GOVERNMENT OF THE DISTRICT OF COLUMBIA
DEPARTMENT OF TRANSPORTATION

MEMORANDUM

SUBJECT: ZC Case No. 18-03 – 4611-4615 41st Street NW (Dancing Crab Properties)

Figure 1 – Gross Floor Area Section (Source: Applicant – Dated March 19, 2018)

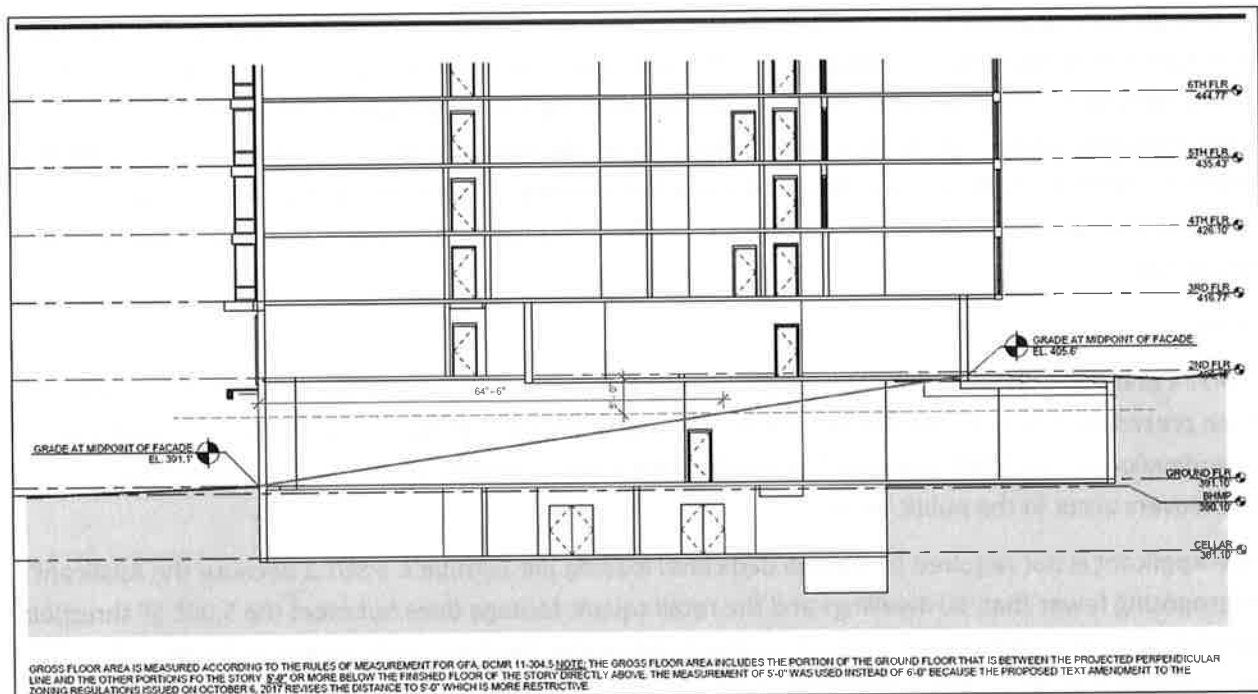
Because the proposed building is tucked into the slope of the site's existing topography as depicted in the section shown in Figure 1 below, much of the ground floor retail space does not count toward the Applicant's GFA, which is used to determine the Applicant's parking and loading requirements. If the same building were situated on a flat plane, the Applicant would likely fall above the threshold requirement for dedicated loading facilities and would be required to provide at least one (1) 30-foot loading berth. DDOT finds the Applicant's loading proposal sufficient to meet the building's anticipated

loading needs assuming the implementation of a Loading Management Plan (LMP). An LMP should be submitted to and reviewed and approved by DDOT.

Figure 3 – Bulb-Out and Alternative Crossing Proposal (Source: Applicant’s Prehearing Statement Plans – September 7, 2018)

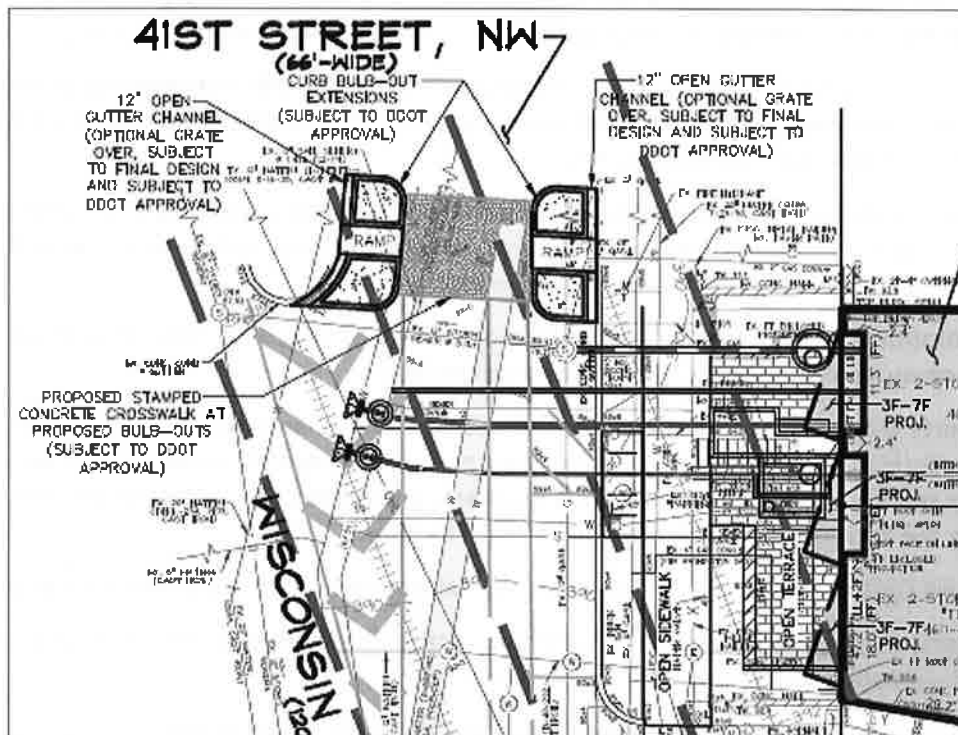
- As part of its public amenities package, the Applicant proposes to provide two (2) pedestrian bulb-out curb extensions (see Figure 3 below). These are intended to reduce pedestrian crossing distances, vehicle approach speeds, and improve visibility. While DDOT conceptually approves of the design, the elements will require rigorous review during the Public Space Permitting Process; and
- In addition, the Applicant proposes a stamped concrete crosswalk across 41st Street NW just north of Wisconsin Avenue NW. This element is aesthetic and does not improve safety conditions for pedestrians. Because maintenance and repair of stamped concrete and asphalt treatments are challenging, particularly in locations with nearby utilities, DDOT is unlikely to accept this proposal and may request standard or other alternative treatments during the permitting process.

Wisconsin Avenue NW. Often vehicles entering 41st Street NW approach 41st Street at speeds consistent with the flow of traffic on Wisconsin Avenue. Beyond speed, the potential for pedestrian and vehicle conflicts are enhanced by the inclining grade of 41st Street NW and the location of vehicle parking on the eastern side of 41st Street NW. As a component of its public amenities package, the Applicant has offered to provide DDOT with two (2) pedestrian bulb-outs. The bulb-outs, shown in Figure 3 below, are intended to reduce crossing distances, improve visibility of pedestrians for drivers, and slow drivers as they move from Wisconsin Avenue’s commercial corridor into the predominantly residential neighborhoods north of the site. The bulb-outs contain two gutter channels to ensure proper stormwater drainage, which will require the Applicant to enter into a maintenance covenant with the DDOT. DDOT finds the preliminary concept acceptable and encourages the Applicant to work with the Transportation Operations and Safety Division (TOSD) to advance the final design, which is subject to DDOT’s review and approval.

At the same location, the Applicant has proposed to provide a stamped concrete crosswalk as a component of its public amenities package. While aesthetically pleasing initially, these treatments often require continued maintenance and can wear over time. Additionally, when utility companies disrupt the pavement beneath the crosswalk for maintenance or repair, they are generally not equipped with the same stamping patterns and simply fill the work area with asphalt, which detracts from the intended look of the treatment. DDOT notes that there is a 36-inch waterline under the location of the proposed crossing. For the reasons discussed above, it is unlikely that DDOT will approve an alternative paving crosswalk design at this location. The Applicant and DDOT may continue to coordinate on public space design and associated safety improvement during the public space permitting process.

- As proposed by the Applicant, design, fund, and install the proposed curb bulb-outs to facilitate safer pedestrians crossings over 41st Street NW. The bulb-outs should be designed to reduce crossing distances, reduce vehicle approach speeds, and improve drivers' abilities to see pedestrians. All proposals are subject to DDOT's review and approval;
